CITY OF JOPLIN
ADDENDUM NUMBER 1

Project Name: Fire Station Concrete Apron Approach Project

PAVEMENT JOINTING PLAN

SHEET NUMBER
C103

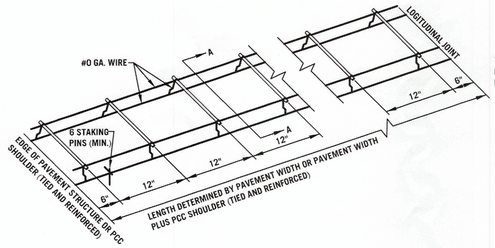
2) **Concrete Reinforcement:** The concrete will require reinforcement in accordance with Sheet Number C103 which is attached to the Addendum.
